Comments of US Tire Manufacturers Association and Tire and Rubber Association of Canada

RE: Comments on Replacement Tire Efficiency Pre-Rulemaking Staff Workshop February 14, 2023 (CEC Docket No. 20-Tire-01)

Figure 1 Illustration of Impact of Proposed CEC Limits (based on 8500+ datapoints)

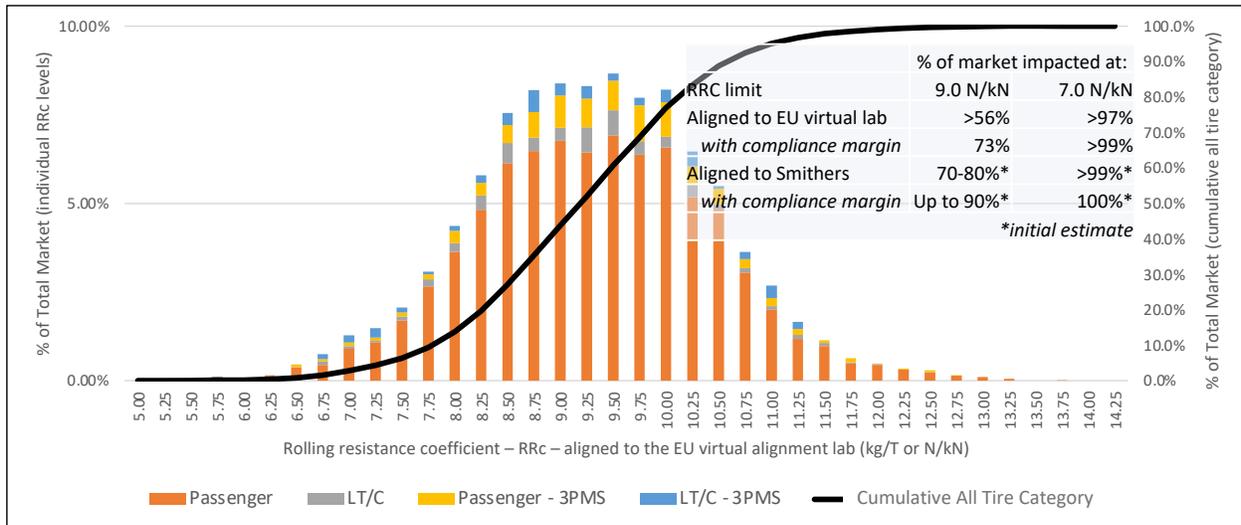
Figure 1 shows the U.S. distribution of tire rolling resistance coefficient (tire efficiency) based on a USTMA/TRAC database of over 8,500 rows of data on tires sold in the North American market and confirmed to be sold in the U.S.⁴ Depending on how CEC defines laboratory alignment for purposes of the regulation and accounting for an adequate compliance margin in tire design and manufacturing, USTMA/TRAC estimate that between 73 and 90 percent of tires in the market today would not meet the minimum performance standard of 9.0 N/kN proposed to take effect 1/1/2026. By 2028, 99 to 100 percent of current tires would not meet the proposed 7.0 N/kN minimum performance standard.

Table 1 National Median Mileage vs. UTQG Treadwear Ratings (Source: Discount Tire Treadwell Program)

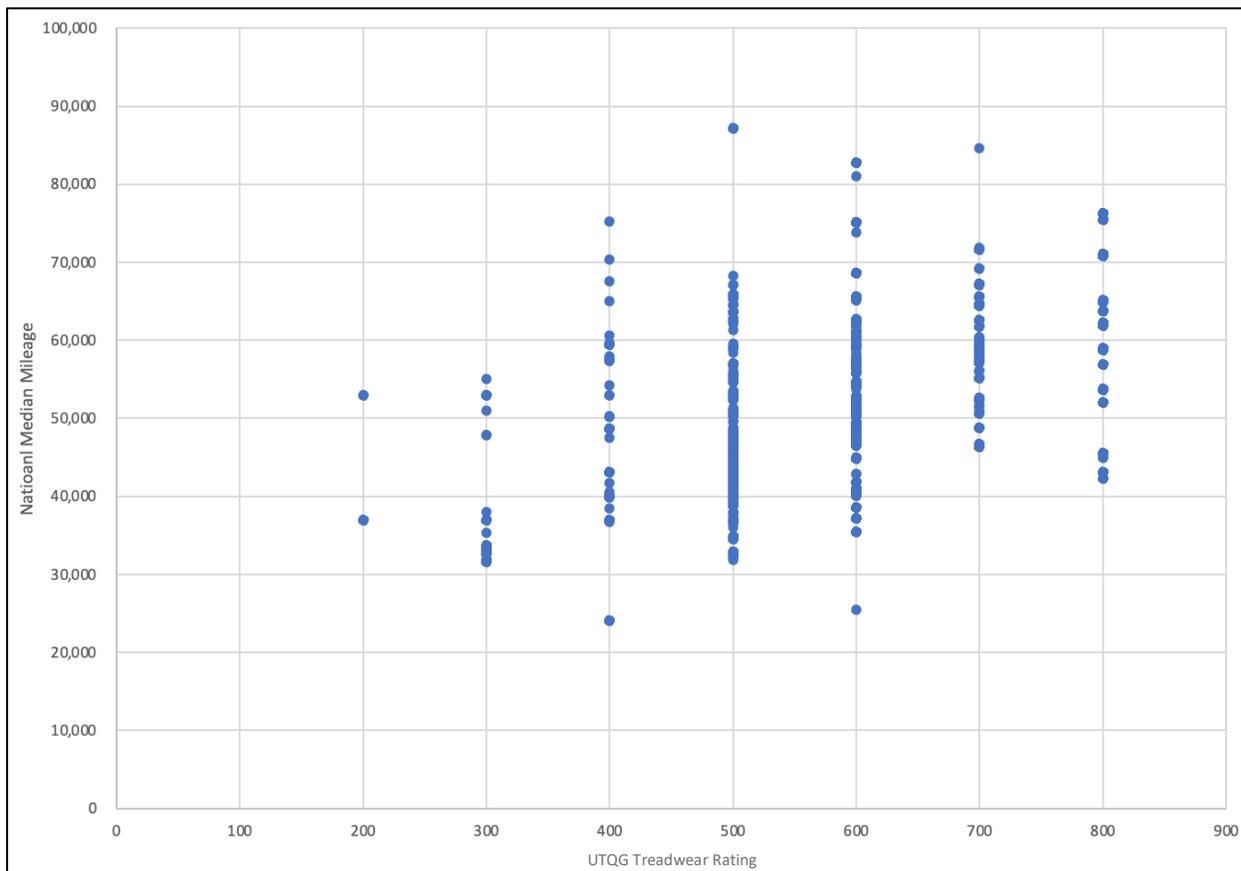
It is the industry consensus that UTQG Treadwear rating is not a good indicator for actual treadwear of a tire. This claim is directly supported by the mileage data from Discount Tire. In a preliminary study, Discount Tire combined all raw data of different brands, tire lines, tire sizes, regions to develop a simple data series of each UTQG treadwear rating and associated projected mileages on customer vehicles. In Table 1, each dot represents the assigned UTQG rating and a projected mileage (in 000) on customer vehicles. This graph clearly shows the wide range of projected mileage for each UTQG rating, and the ranges overlap among different

UTQG ratings. For example, tires with UTQG treadwear rating 400 have a wide range of 24,000 and 75,000 projected miles on customer vehicles.

Figure 2 Comparison of United States, Canadian and European Passenger Car Tire Markets

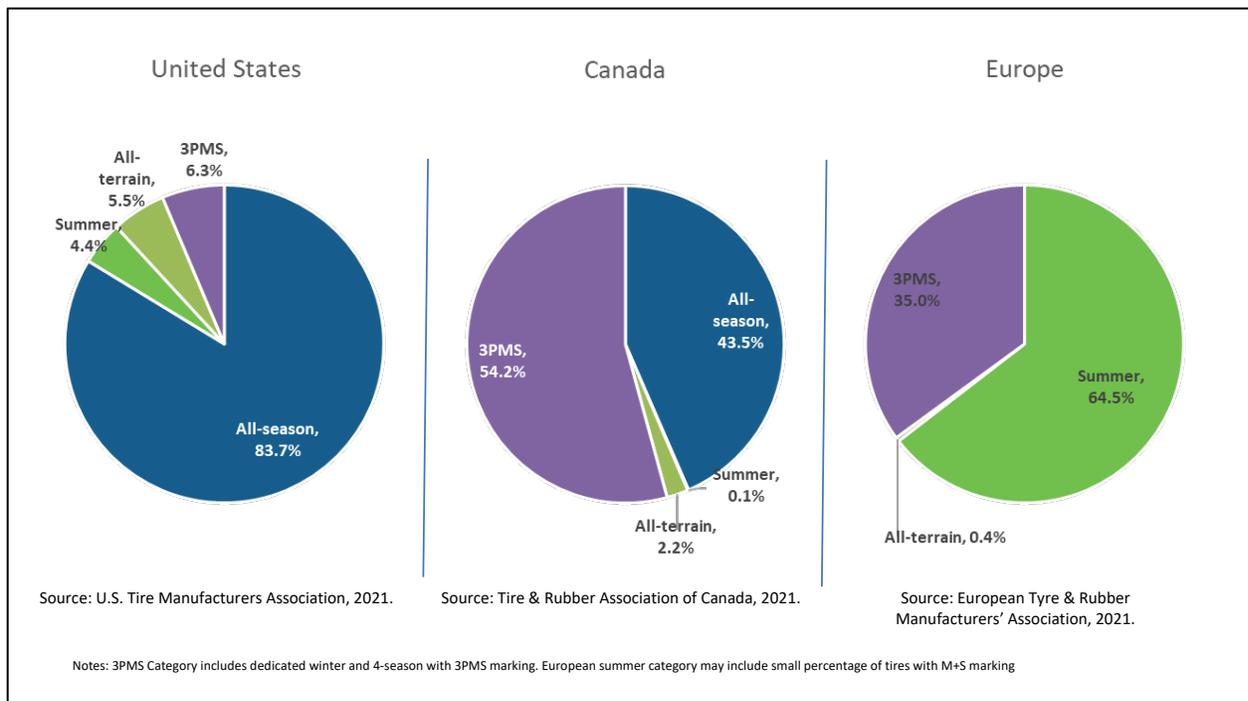
Finally, the Draft Framework mentions that “a significant number of tires are tested to the required parameters as a baseline because of international regulations such as those in effect in the European Union.”¹⁸ To clarify, the vast majority of tires that are sold in the U.S. and Canada are not sold in Europe and therefore do not need to be tested to UNECE Regulation No. 117 tire rolling resistance minimum performance standards or rated according to the European Commission rating system for tires. As a reminder, as USTMA presented during the February 2021 and February 2023 CEC Staff Workshops, the U.S. and European tire markets are very different. As seen in Figure 2, the U.S. passenger tire market is dominated by all-season tires at 83.7 % of the market. In California, this number is likely higher, since winter tires (tires with 3-peak mountain snowflake or “3PMS” markings) are not common purchases in the state. In contrast, the European market is composed primarily of summer and winter tires. The North American all-season tire is not a significant product segment in Europe. While some mention in trade press or industry sources may be made of “European all-season” tires, these are not the same products as North American all-season tires. European all-season tires contain the 3-Peak

Mountain Snowflake (3PMS) symbol and if they are sold in North America, they are included in the 3PMS category in Figure 2 and referred to as “all-weather” tires.
